File Numbers: D07-16-19-0026, D02-02-19-0123

Re: Draft Plan of Subdivision and Zoning By-law Amendment – 7000 Campeau Drive

The following review comments are provided in response to the second submission of the Draft Plan of Subdivision and Zoning By-law Amendment Applications for the proposed residential development at 7000 Campeau Drive. Please coordinate the changes made in response to the comments below across all plans and reports as applicable.

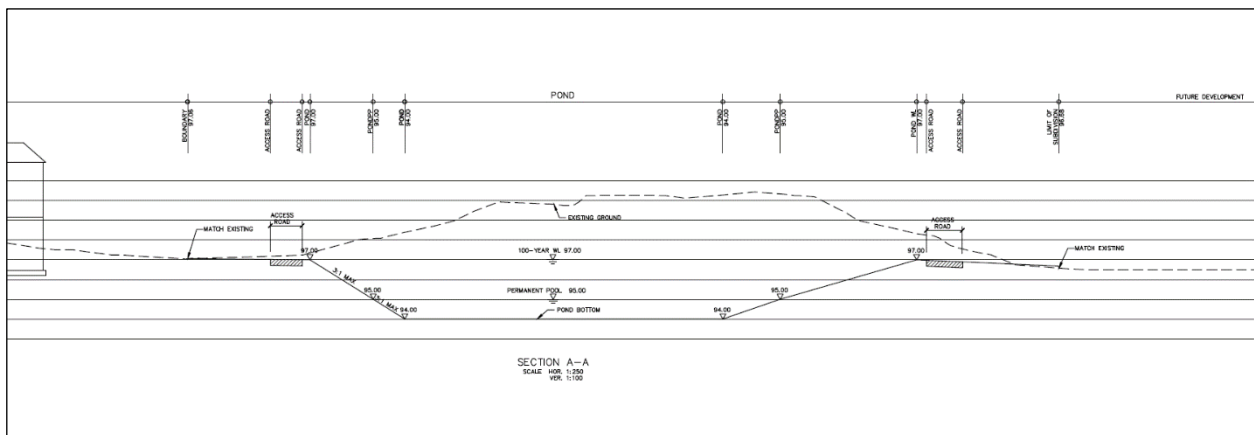
112. The proposed pond blocks are tightly packed into the development. Please allow sufficient area for appropriate perimeter grading, pond maintenance access, sediment forebay, sediment drying area located near the sediment forebay as much as possible, wet cell, service roads with a minimum offset of 5.0m from private properties. The

SWM facility is to be accessible from municipal roads and the facility should be designed to minimize the number of inlets.

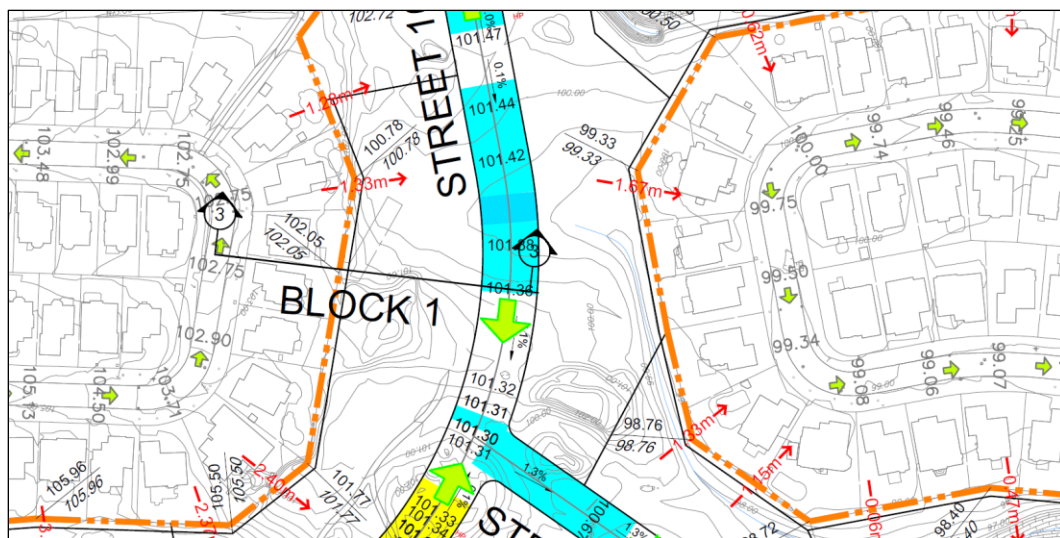
Its not clear how 100 % of the existing RY drainage for the existing lots on Zokol Street will flow to Street 16 dual drainage system as modelled (see screenshot of the PCSWMM model below).

Please extend section line 3-3 to include the proposed and existing lot east of Street 16 to Zokol Street.

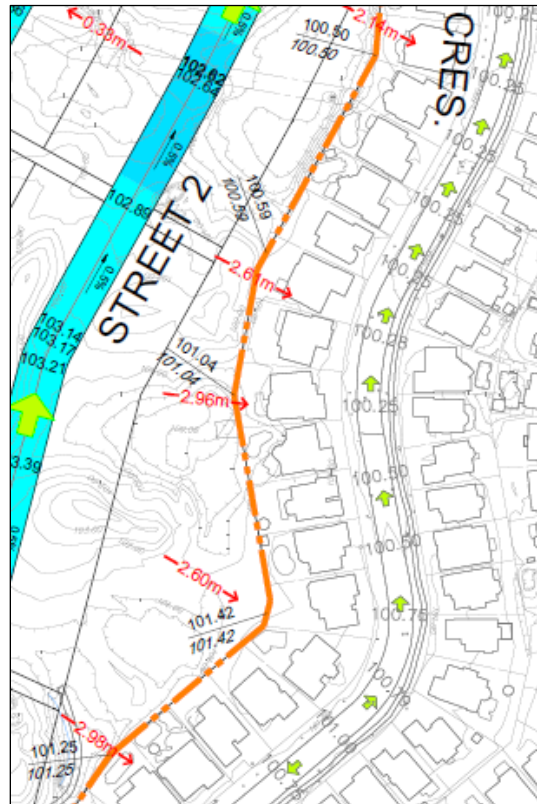
Example 2: With respect to the screenshot below of the preliminary grading plan and section 2-2, how will it be possible to convey 100% of rear yard drainage from new proposed RYs and existing RYs for homes on Slade Cres, to Street 16 (where grade raises are proposed)? Based on Section 2-2 (see screenshot below), it would appear all drainage from the proposed lot will flow directly into the existing lots located on Slade Crescent and likely onto Zokol Cres. (it does not appear that RY swale is proposed either). Please extend Section 2-2 to Zokol Cres. and revise subcatchment outlets and/or RY routing to address this.

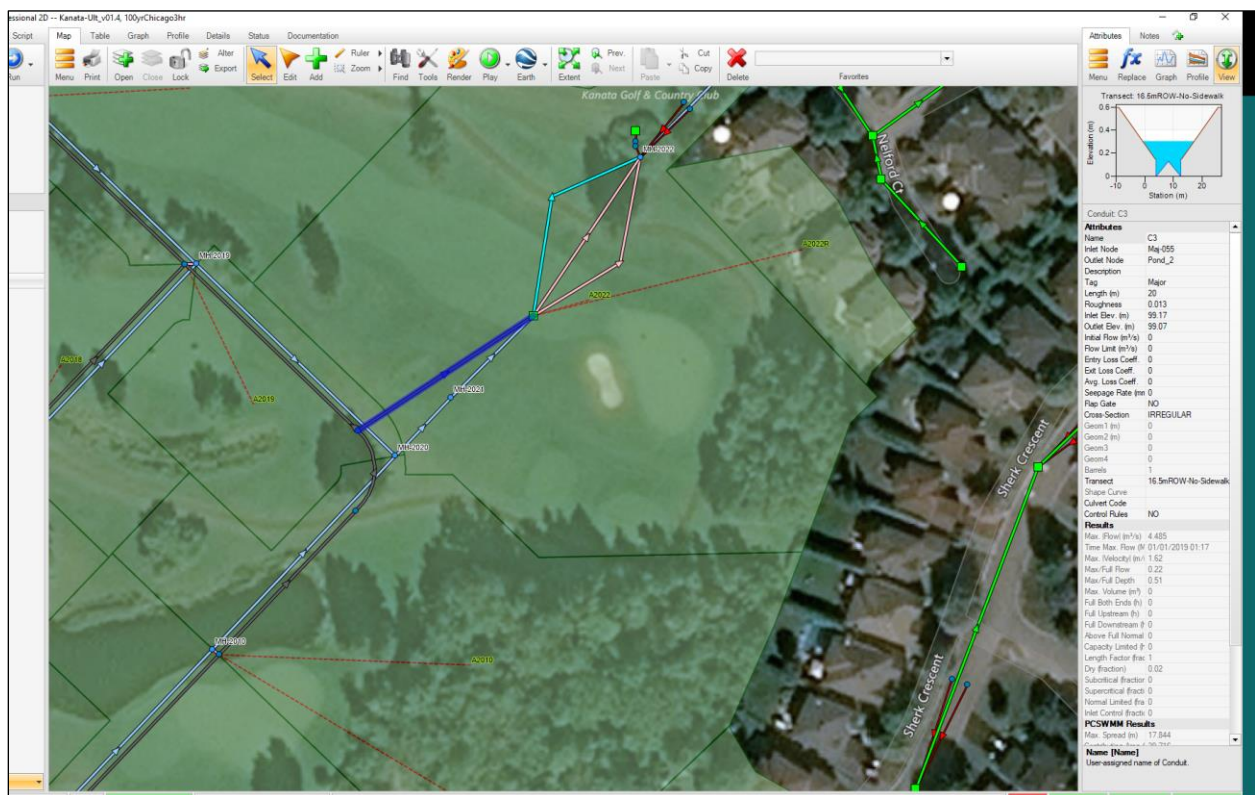
- Would adding saw tooth major system (and accounting for RY overflow routing) impact both major system and minor system results both in existing and the proposed development.

Please revise the model to include existing major system and routing per the comments in this memo. Please provide full dynamic wave models for both existing and proposed development (vs the combination of kinematic wave and dynamic wave).

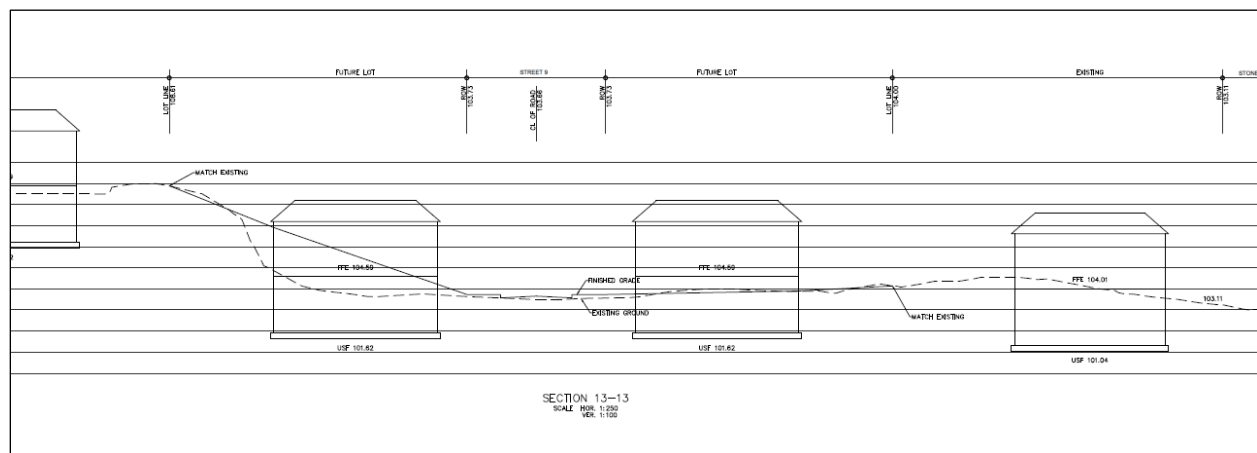
134. 100% Capture at low points – what type of CB structure is proposed to convey flows up to 5 m³/second (OL53 conveys 5 m³/s in the 100 year, 3hr Chicago model submitted). Will updating to a feasible saw tooth design in the right of way to distribute this flow into the minor system, across the subdivision change the results for the minor system HGL?
